CO3275 – Northfield BF 0241(58)

ADDENDUM #2

Changes have been made to the documents located on the Bid Opportunity website as noted below:

TYPICAL ABUTMENT PILE SOCKET DETAIL
(NOT TO SCALE)

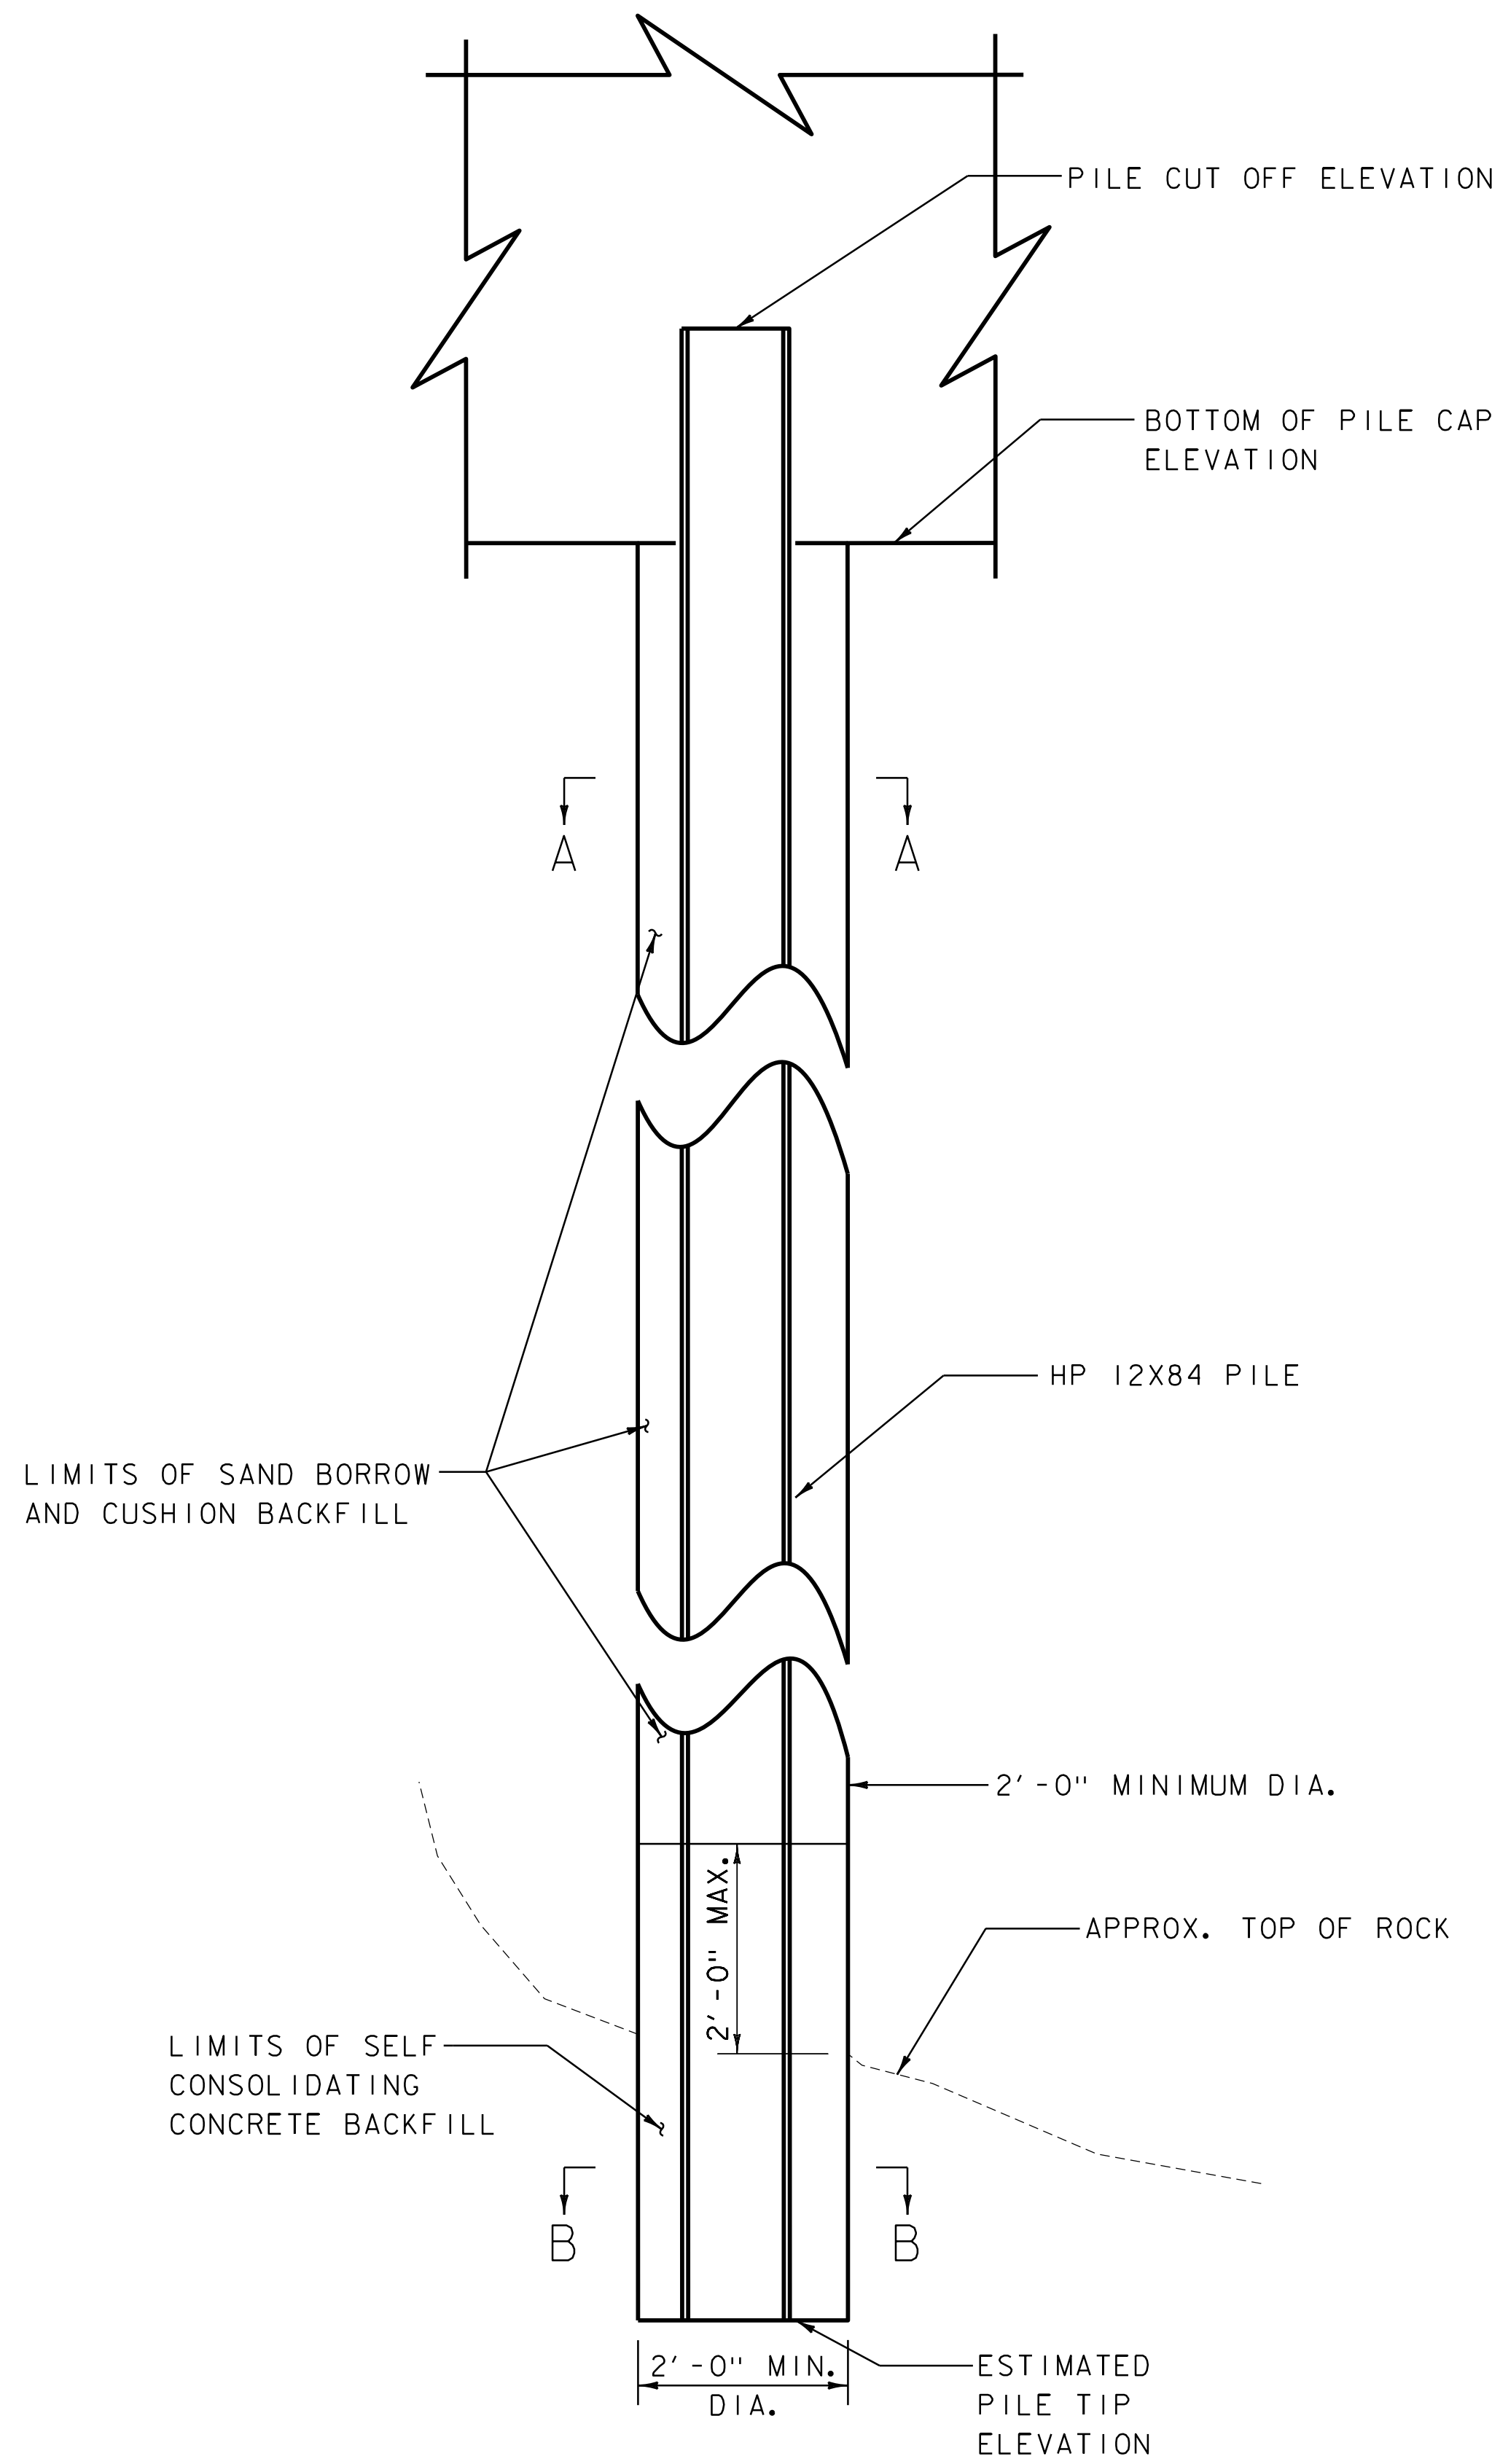
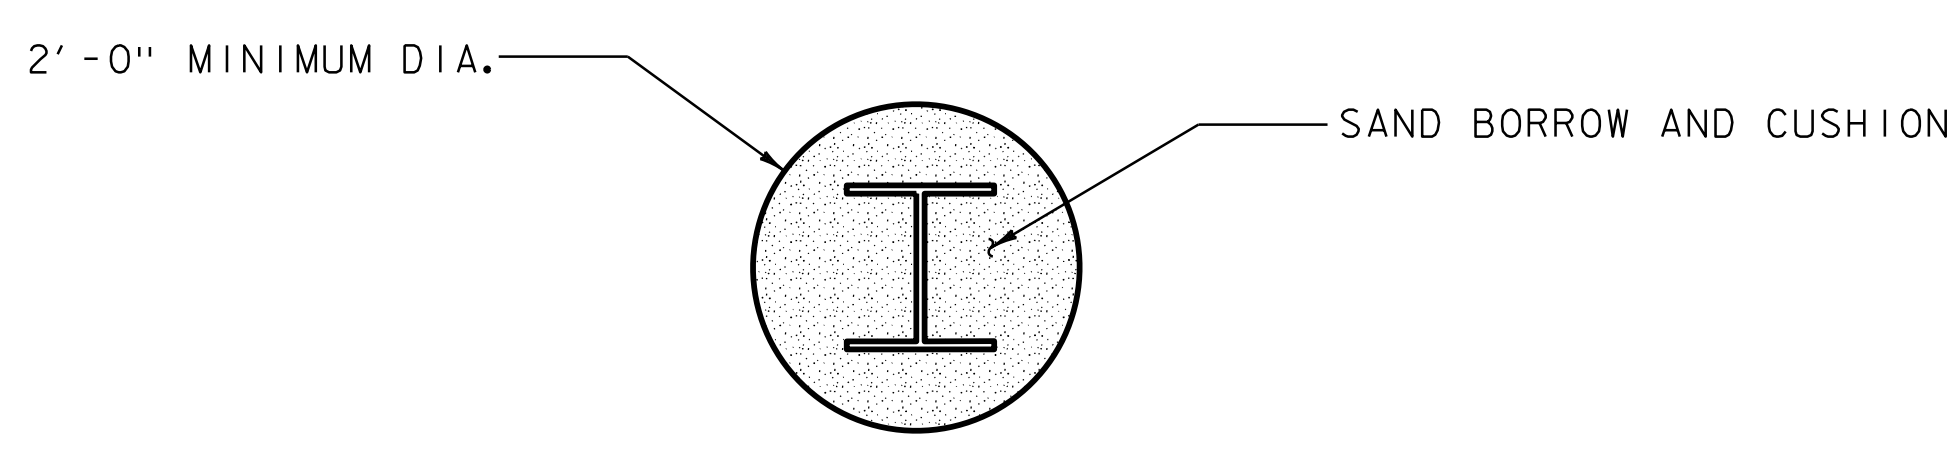
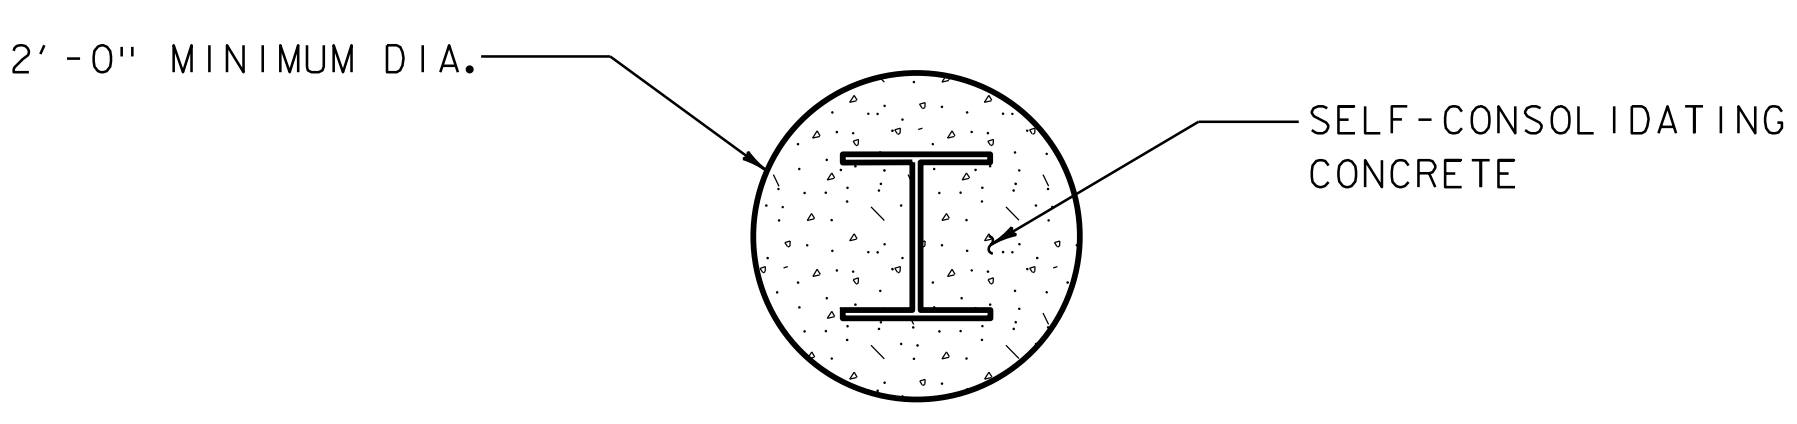
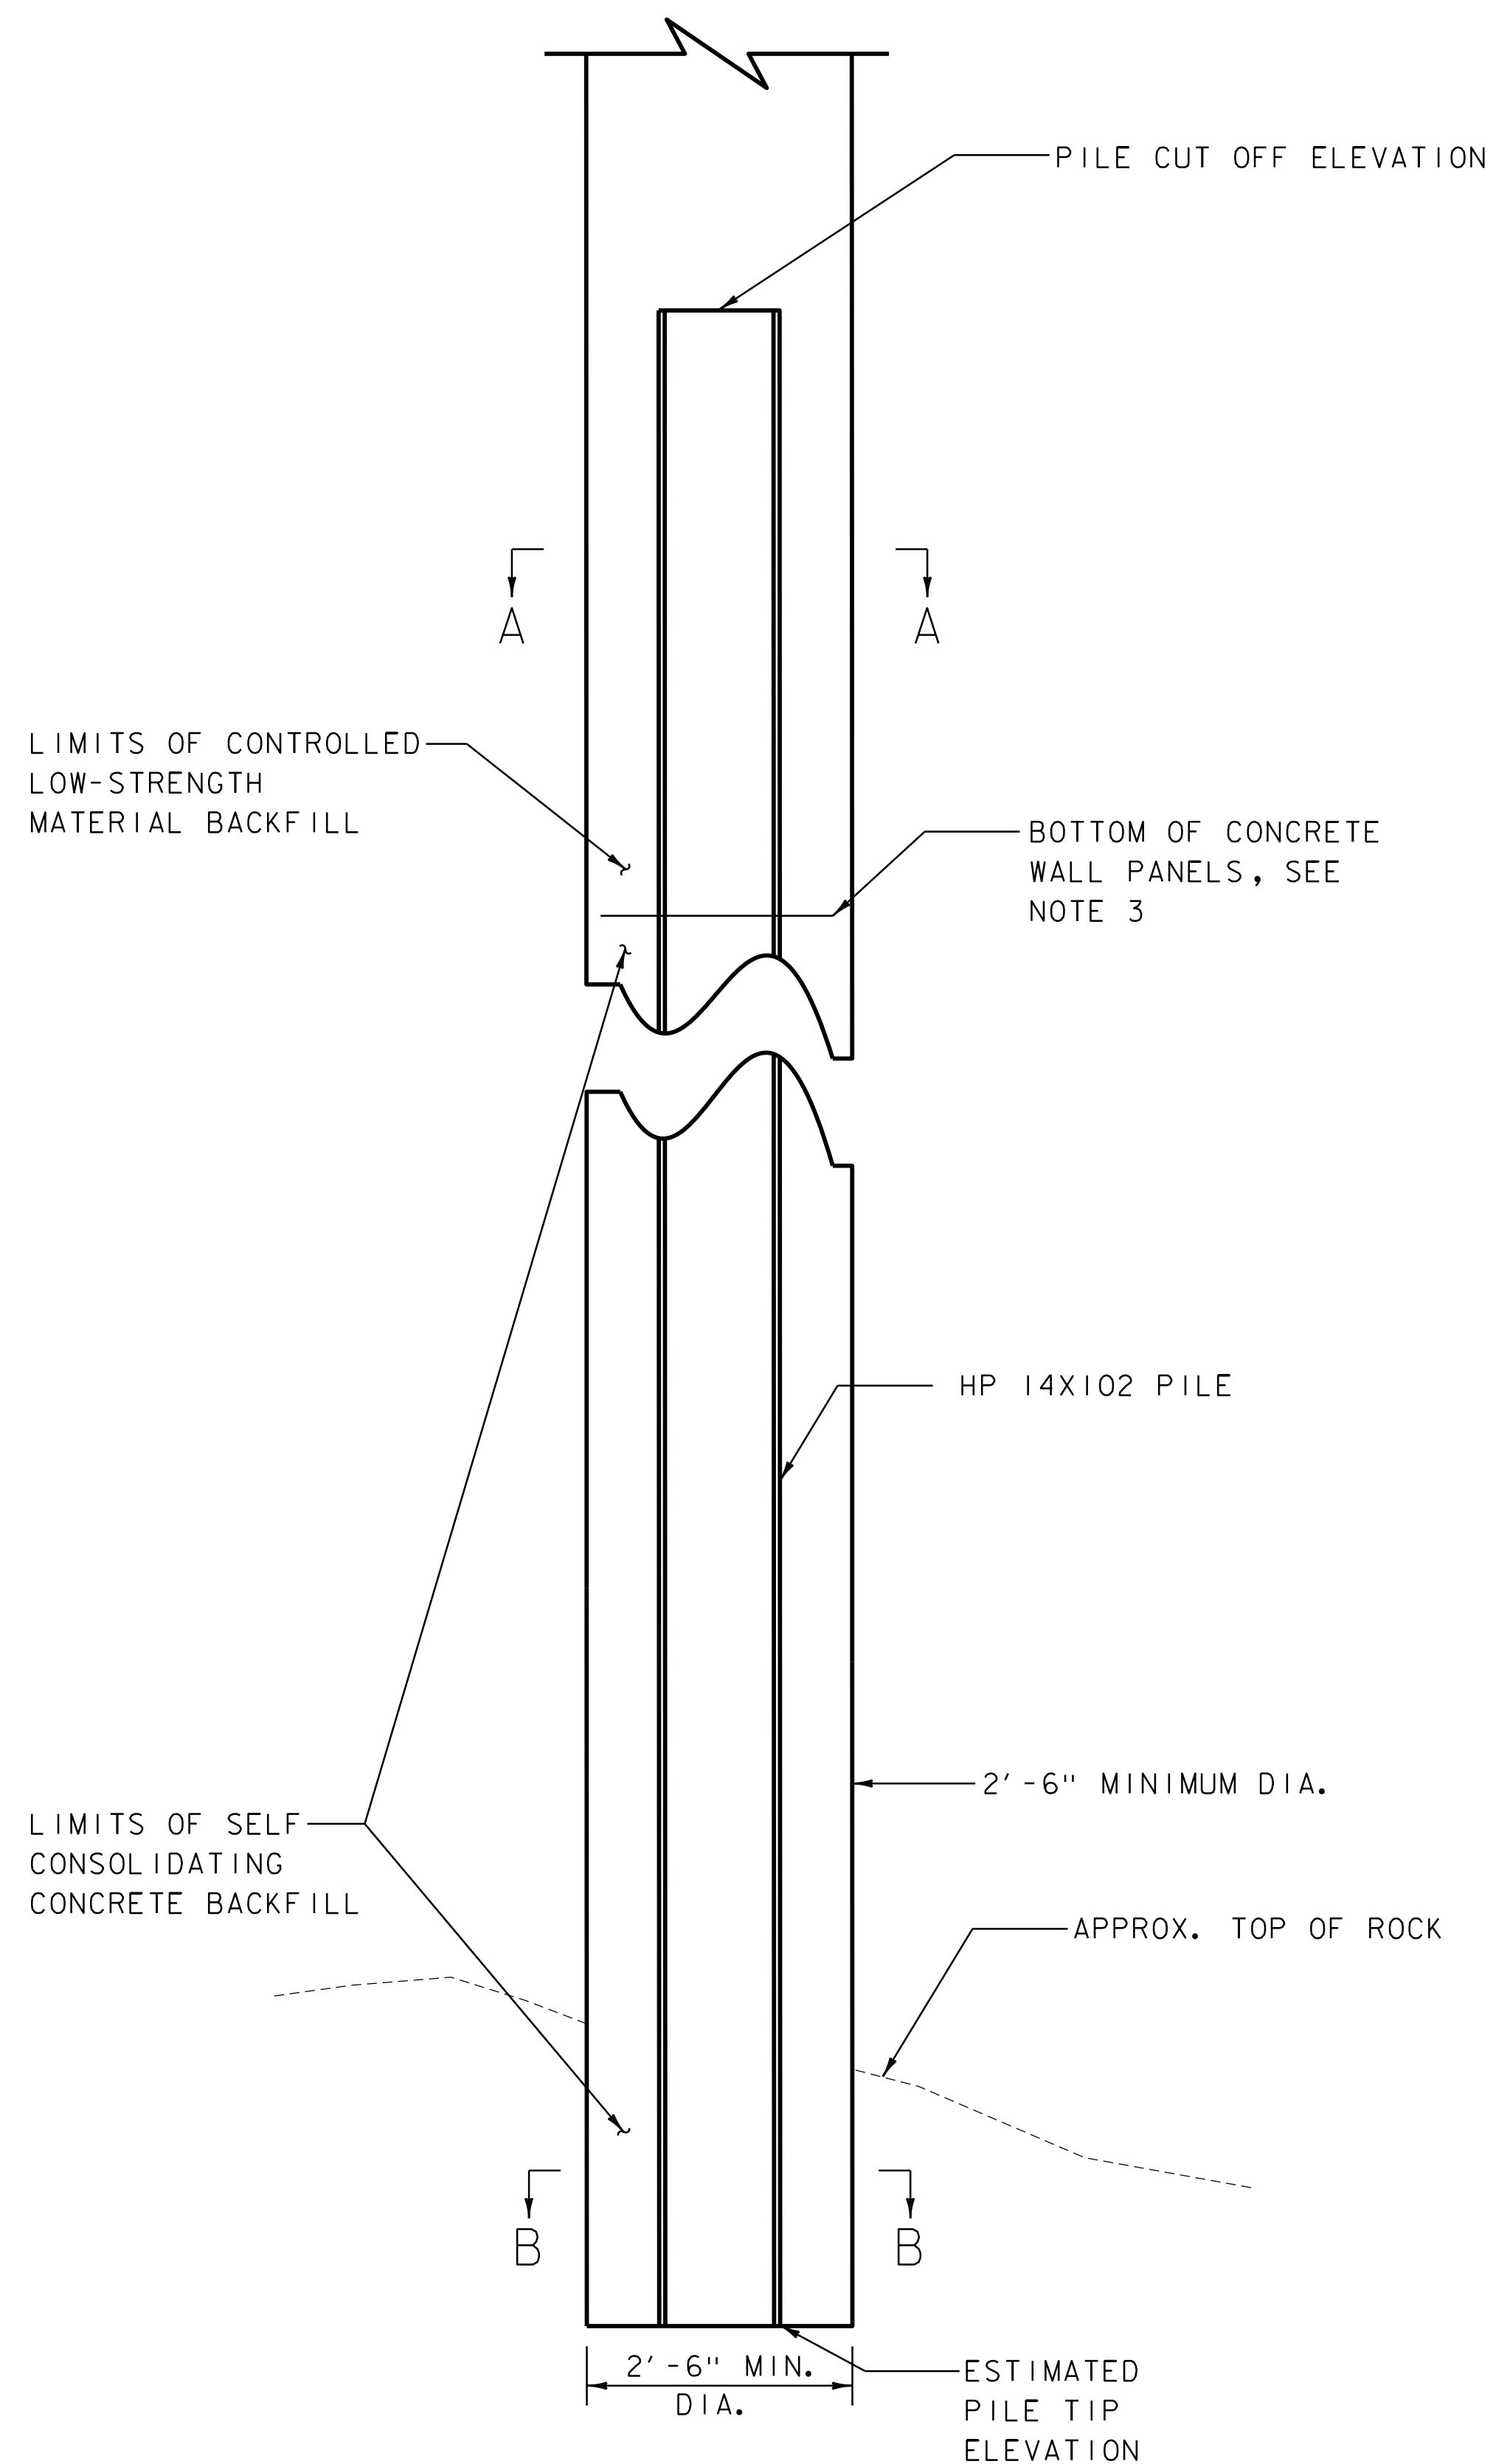
ADDENDUM	REVISION	PLOT DATE	DESCRIPTION	BY
△	1	14-MAY-2026	NOTE ADDED	S. BROWN

1. FOR WINGWALL PILE INFORMATION REFER TO 'WINGWALL PILE DETAIL SHEET'.
2. THE CONTRACTOR SHALL IMMEDIATELY NOTIFY THE ENGINEER IF ACTUAL TOP OF ROCK ELEVATIONS ARE OUTSIDE THE RANGES SHOWN IN THE ABUTMENT PILE SUMMARY TABLE.
3. PILES WILL BE PLACED WITHIN THE PRE-EXCAVATED PILE SOCKETS, BASES CAST INTO CONCRETE, AND BACKFILLED UTILIZING SPECIFIED MATERIALS. SEATING THE PILES INTO THE BEDROCK SOCKETS WITH AN IMPACT PILE DRIVING HAMMER IS NOT REQUIRED.
